Re: Final Environmental Assessment/Negative Declaration
Pedestrian Walkway and Related Improvements
Sheraton Resort
TMK: 2-8-2-16:3, Poipu, Kauai

FINAL ENVIRONMENTAL ASSESSMENT

CONSTRUCTION OF A PEDESTRIAN WALKWAY
Sheraton Kauai Hotel
Koloa, Kauai

APPENDIX A
COMMENT LETTERS AND RESPONSES

REVISED

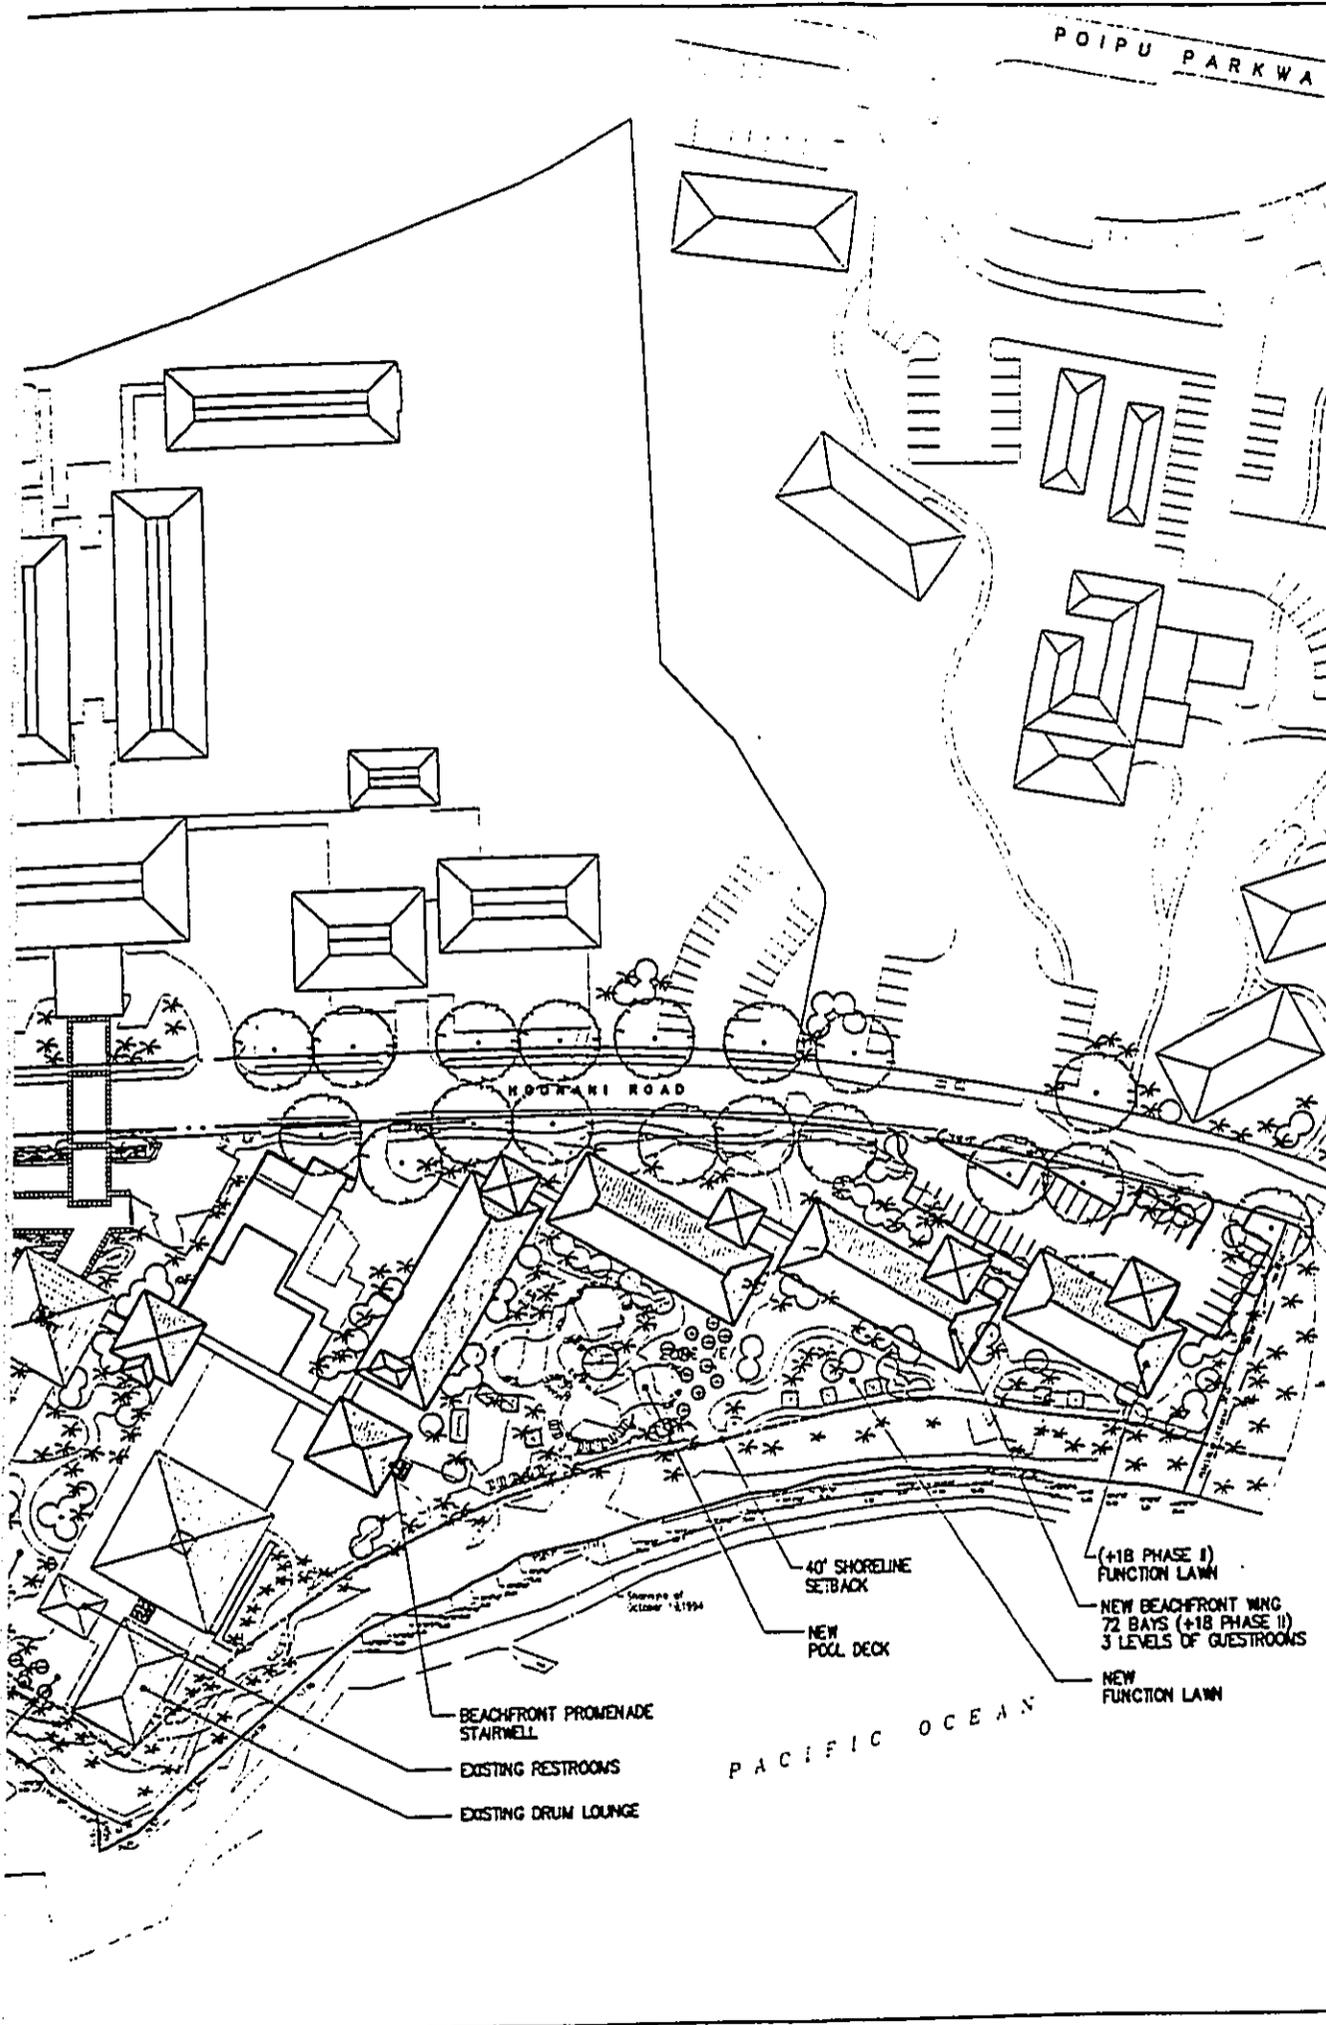
While the Sierra Club enthusiastically supports public access along the shoreline, it may be possible to provide such access without a hardened structure that impacts on beach processes. Alternatively, such a walkway should be placed further mauka to protect beach resources.

- B. The Office notes that the project's master plan as illustrated in Figure 3 shows new structures on site at the Sheraton Kauai such as a new lobby, lounge, gallery, new beachfront wing with 148 rooms, new pool deck and new function lawn. Section 11-200-7, Hawaii Administrative Rules requires that a group of actions proposed by an applicant shall be treated as a single action the component actions are phases or increments of a larger total undertaking. Please discuss the relationship of the proposed walkway as an integral part of these master-planned improvements and the direct, indirect and cumulative impact of these master-planned improvements.

In discussions with the Planning Department, Obayashi has suggested moving the walkway inland away from Poipu Beach and locating it outside the shoreline setback area. This alternative is now possible because Obayashi has voluntarily reduced the density of the oceanfront wing from 134 to 90 rooms and the number of proposed structures from five to four thus freeing ground level space for accessory facilities.

The walkway design criteria and a revised site plan depicting the new walkway alignment shall be included in the Final Environmental Assessment.

- e) See Item 1.
- f) Photos will be submitted to the Planning Department.
- g) In discussions with the Planning Department, Obayashi has suggested moving the walkway inland away from Poipu Beach and locating it outside the shoreline setback area. This alternative is now possible because Obayashi has voluntarily reduced the density of the oceanfront wing from 134 to 90 rooms and the number of proposed structures from five to four thus freeing ground level space for accessory facilities. A revised site plan shall be included in the Final Environmental Assessment.

**SHERATON KAUJAI HOTEL
WALKWAY SECTION**

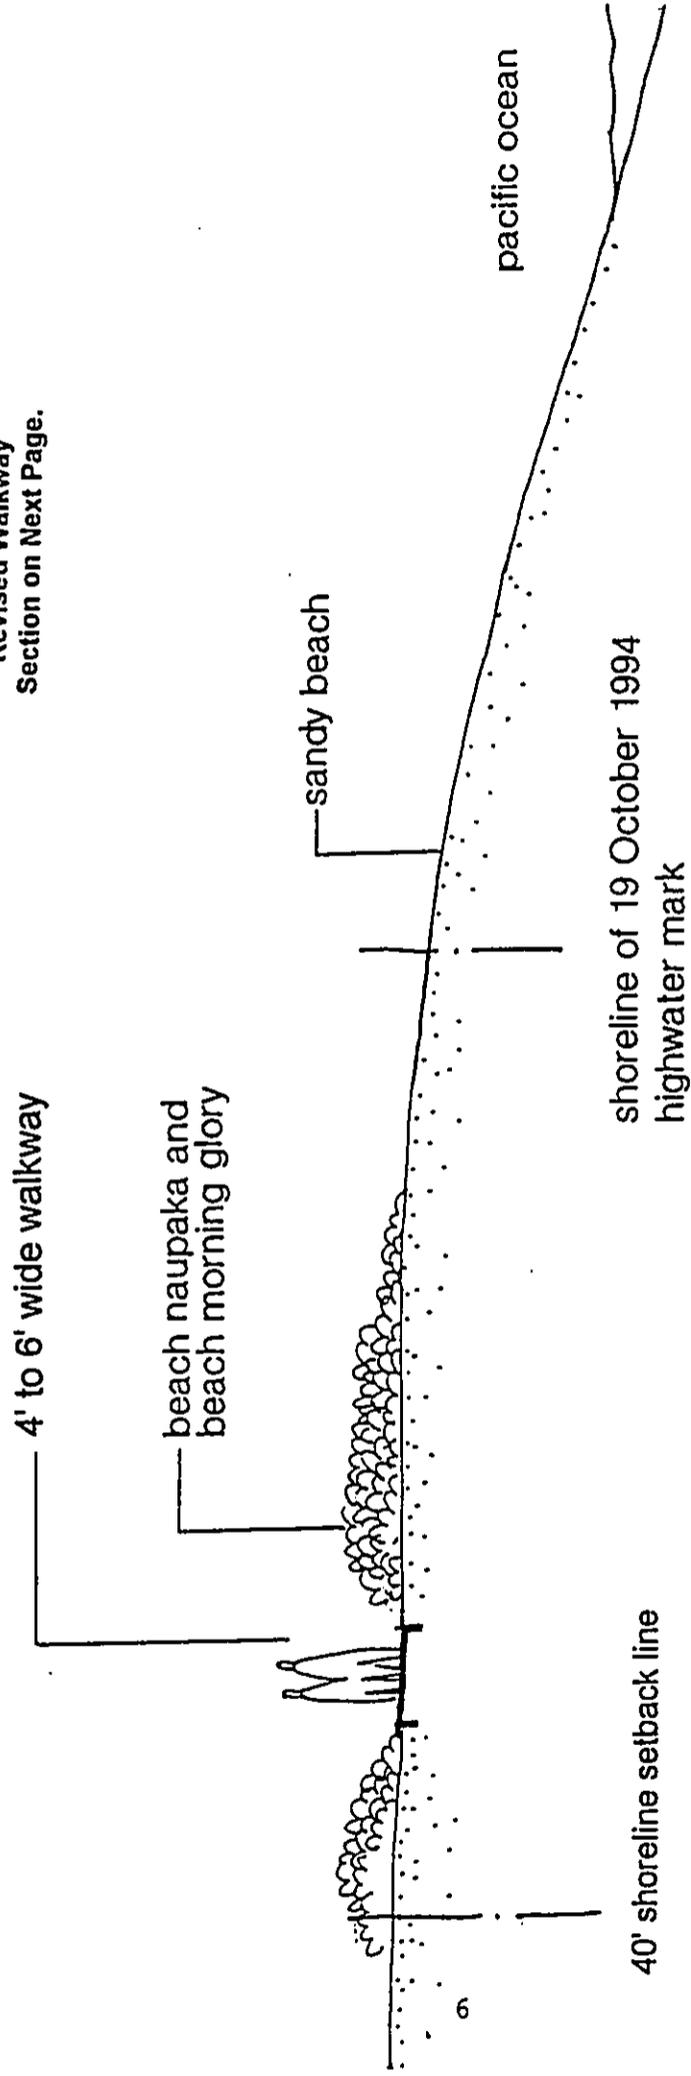
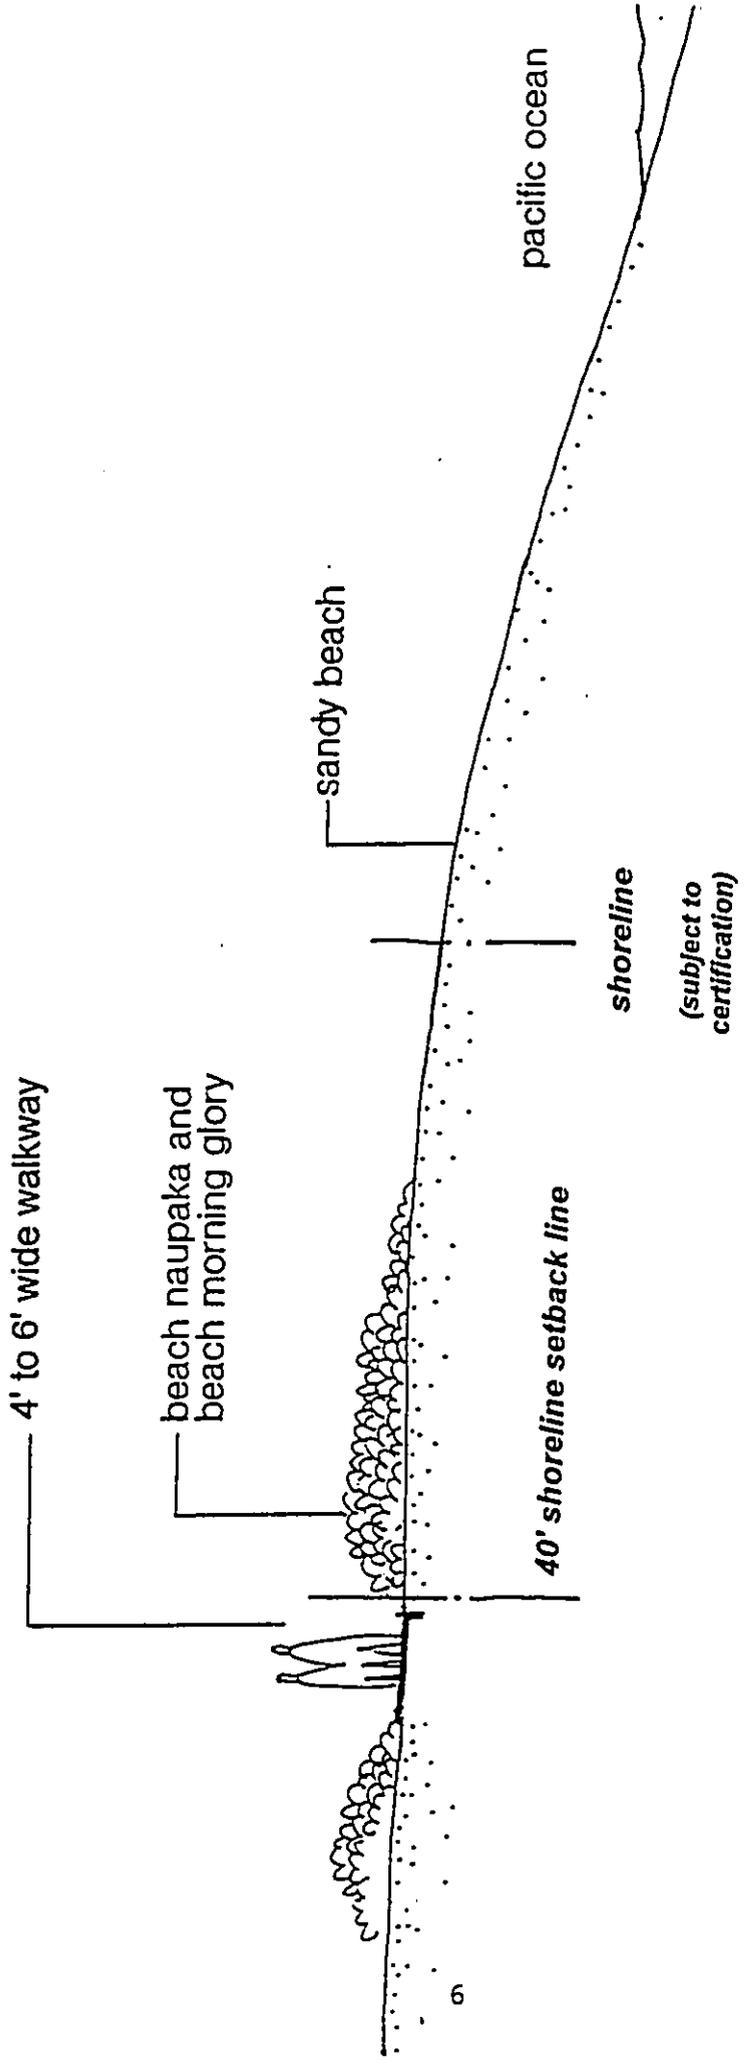
- 2) Since very little information is provided that actually describes the structural aspects of the proposed walkway, it is difficult to predict what potential impact it could have on the littoral dynamics of this sand beach. In other similar cases, substantial foundations and footings of concrete shoreline walkways have acted as vertical seawalls, and adversely affected beach processes when wave run-up reached the concrete structure. Since erosion and beach loss are major coastal planning concerns, especially within the shoreline area of coastal hazard zones such as Poipu, efforts should be made to prevent any significant likelihood of erosion problems resulting from the proposed project. Thus, the final EA should more fully describe the structural aspects of the walkway, and should also consider other creative alternatives to achieve the objective of restoring shoreline access. For example, on page 10, the draft EA notes that part of the accessway was to be a grass walkway. Another possible alternative could be the use of modular wooden plank sections that could be easily moved out of the way during periods of erosion. These alternatives would not only prevent the problems associated with vertical seawalls, but also would prevent the undermining and collapse of concrete walkways that often occurs when they are built upon unconsolidated sand.

2. Applicant does not plan to build a "hardened walkway" or one placed on top of a sub-structure. We agree that if such a structure was to be built near the ocean, the natural movement of sand or surf striking the structure could adversely affect beach processes along the entire shoreline. In our opinion this is not a desirable outcome for the applicant, the County of Kauai, and the public.

The walkway design criteria and a revised site plan depicting the new walkway alignment shall be included in the Final Environmental Assessment.
